35/13-96A 9 West Lenox Street  
(Chevy Chase Village Historic District)

HISTORIC PRESERVATION COMMISSION STAFF REPORT

Address: 9 West Lenox Street

Case Number: 35/13-96A

1916 SANBORN FIRE INSURANCE MAP  
Univ. of Md, Maryland Room

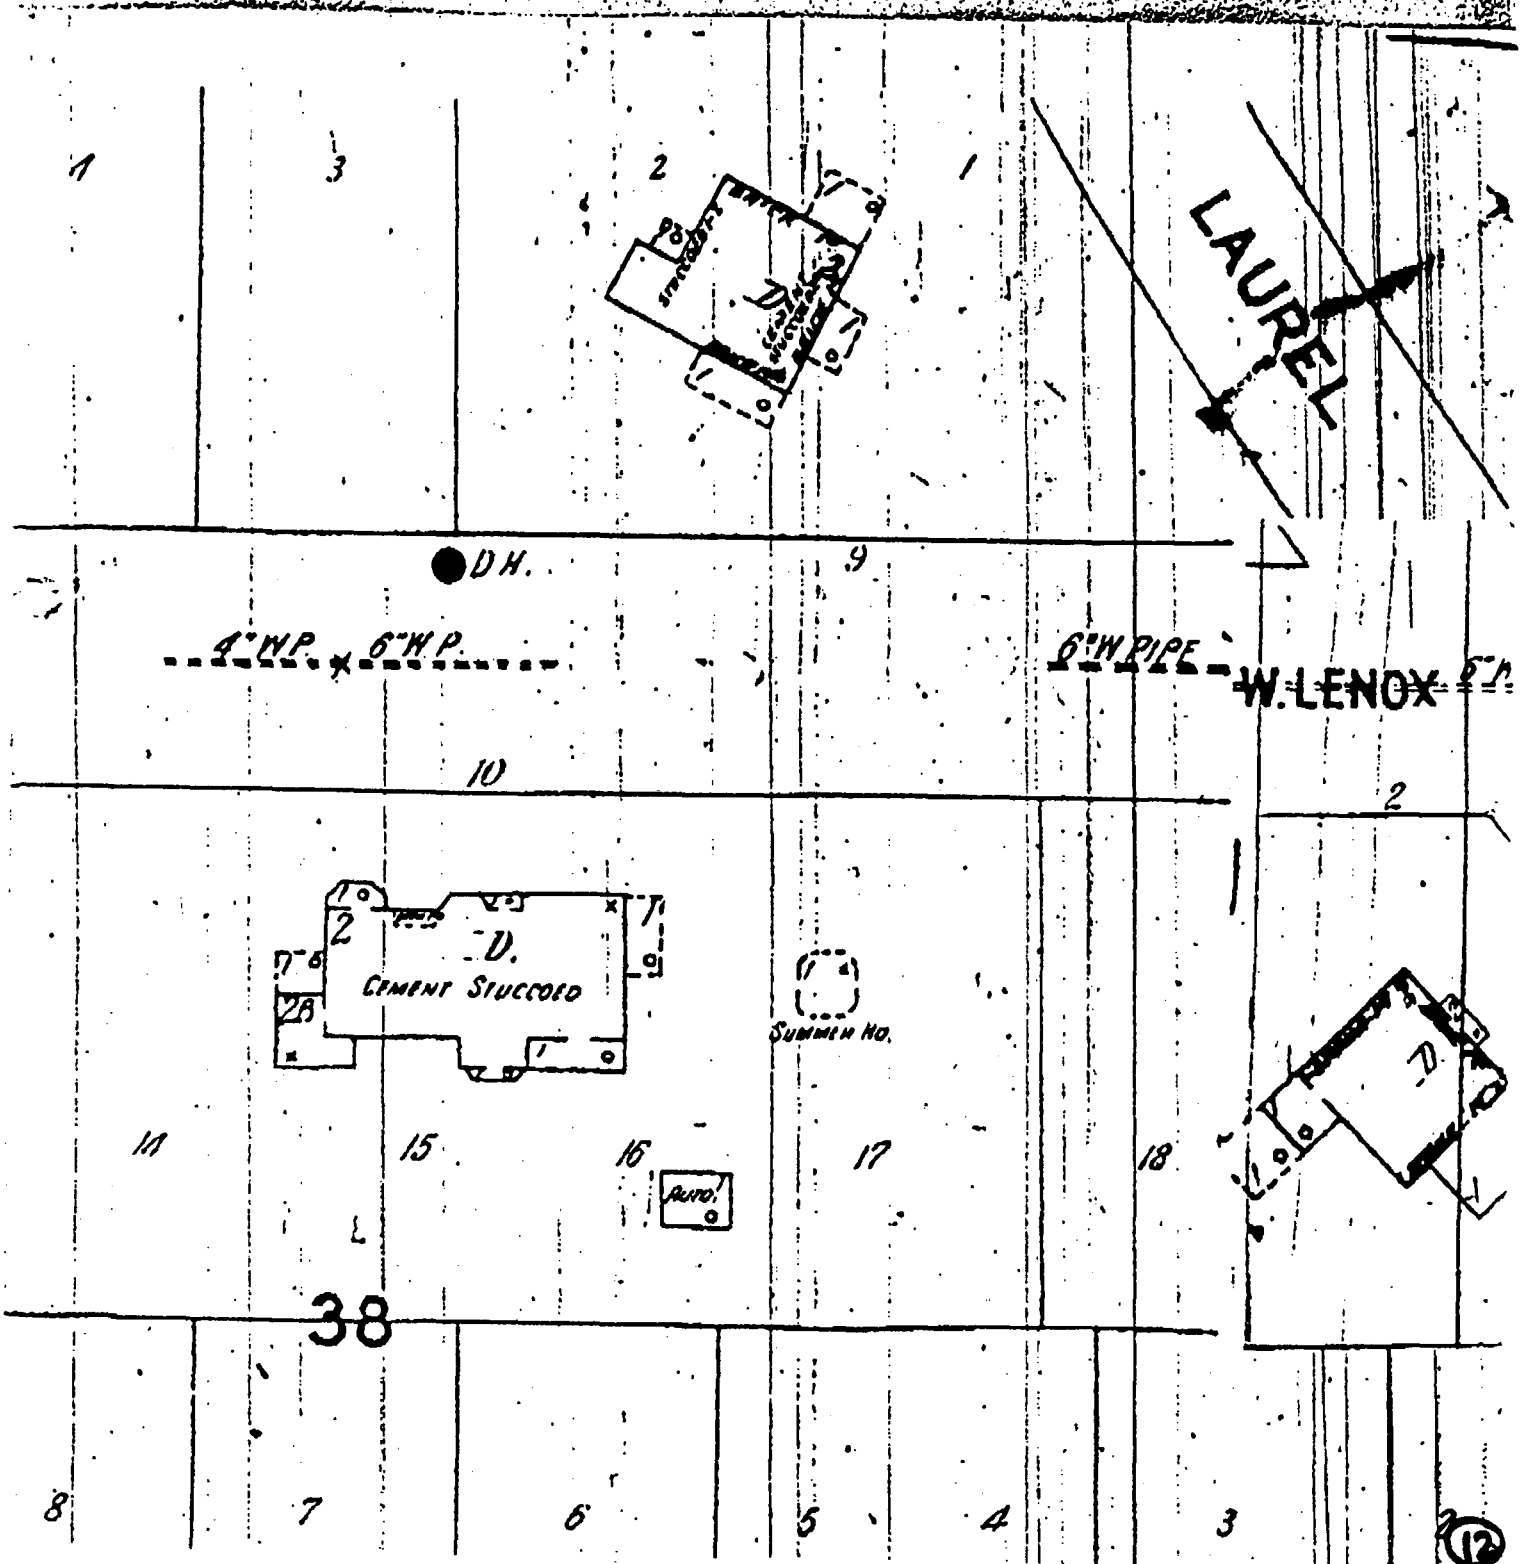
The additions/extensions to the porch are consistent with the architecture of the house. But staff is concerned about the applicant's proposal to remove the existing balustrade. The porches appear in the Sanborn map of 1916 (an enlarged copy is included by the applicant as part of the HAWP submission). Records of Montgomery County Office of Permits indicates that a permit was granted to construct a porch. Staff is unclear as to whether this porch was a rear porch addition or a change made to the porches which partially wrap the facade. Therefore it is still unclear as to whether the existing porch elements are original or a replacement.

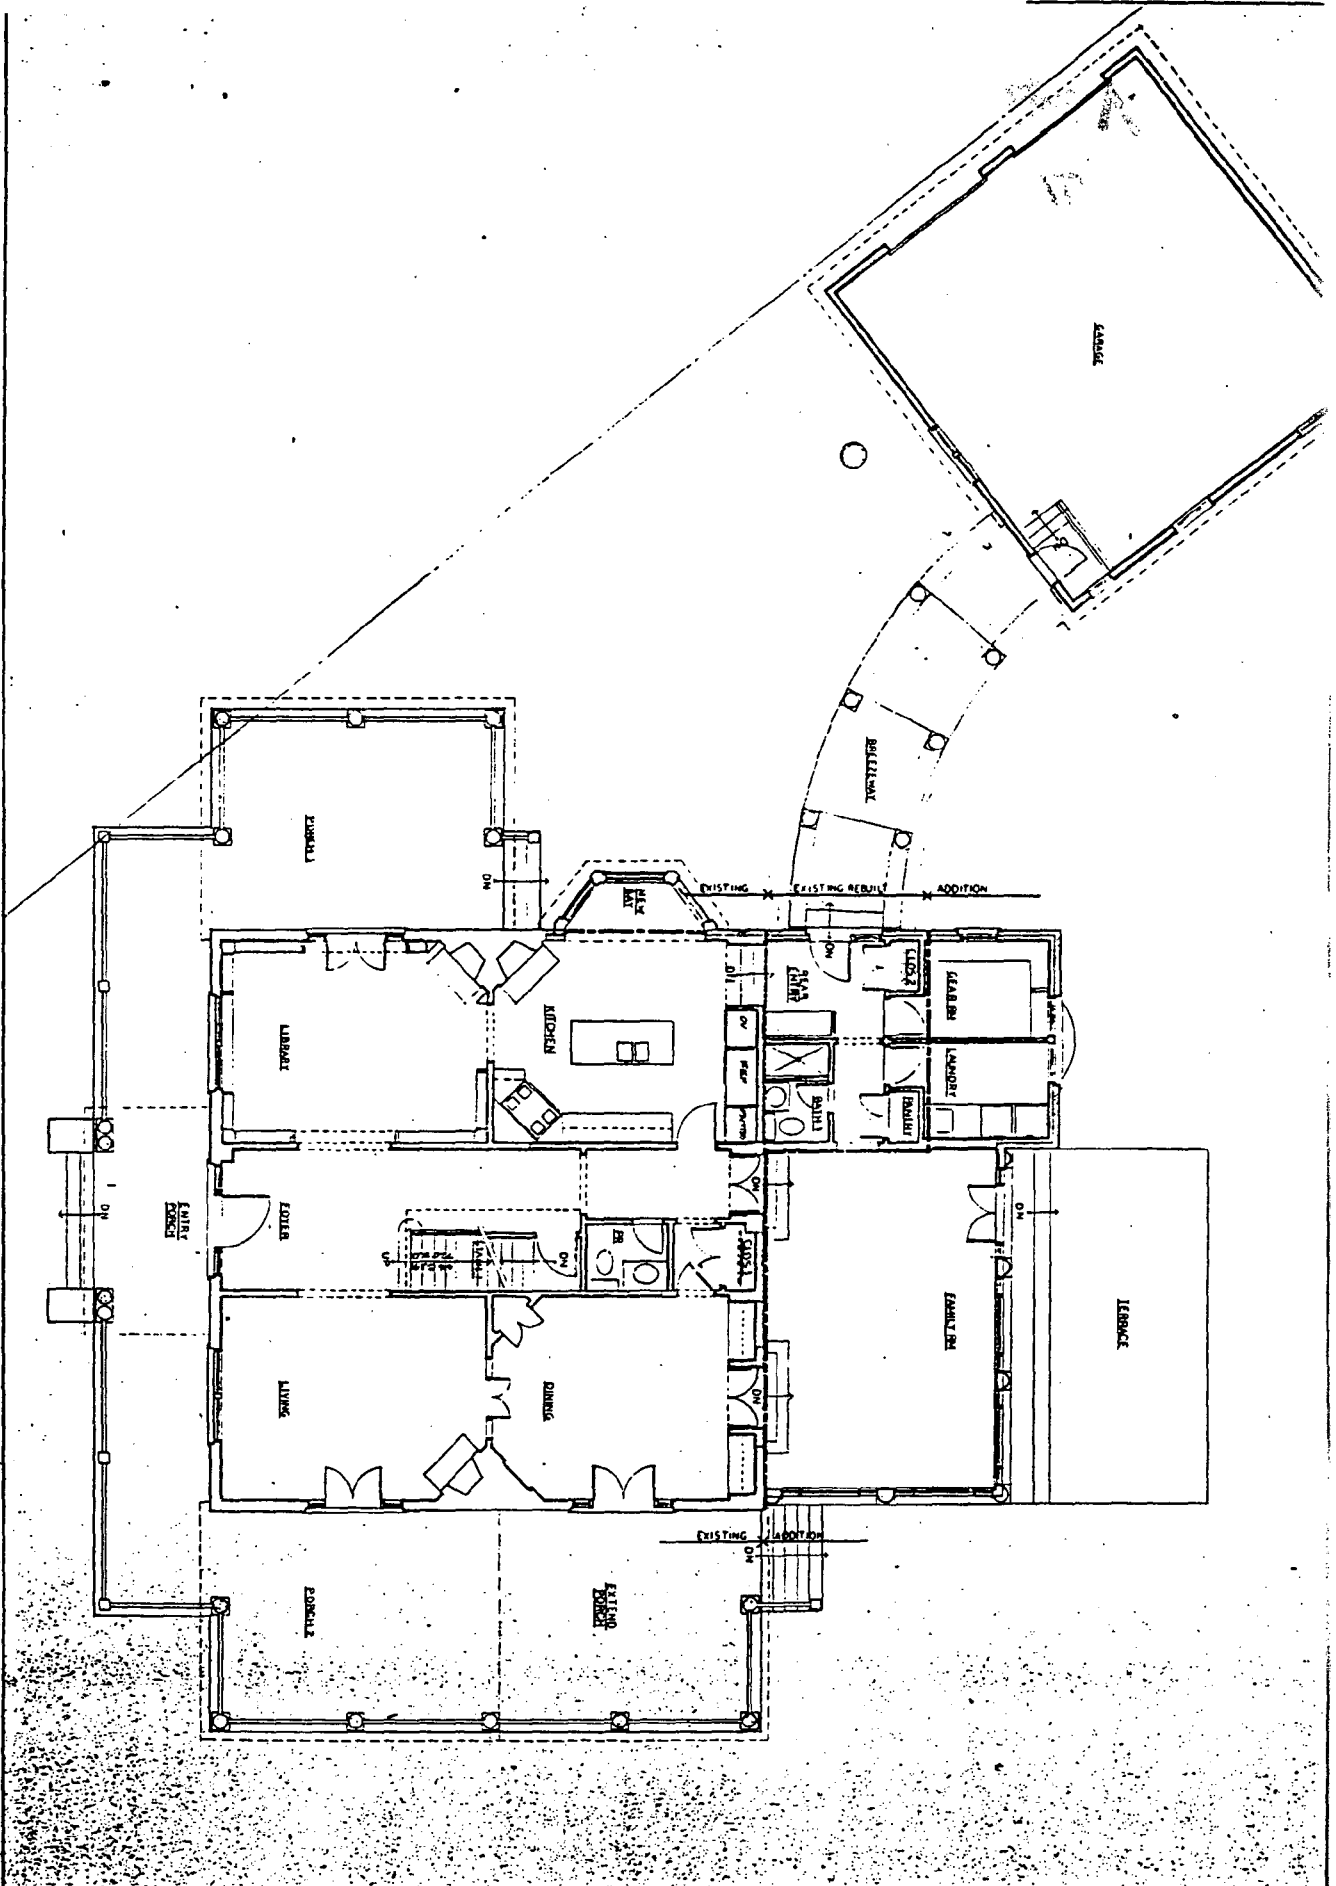
The Chevy Chase Village Board did not grant our request for a variance to allow the extension of the Laurel Parkway side porch, a small triangular portion of which lies over the building restriction line

(shown hatched on the First Floor Plan). The board chairperson called me the day after the hearing to say that the board strongly approves of the porch extension, and would like the HPC to grant the applicant permission to reduce the depth of the existing porch so that the extension could be made in a straight line without a notch or setback.
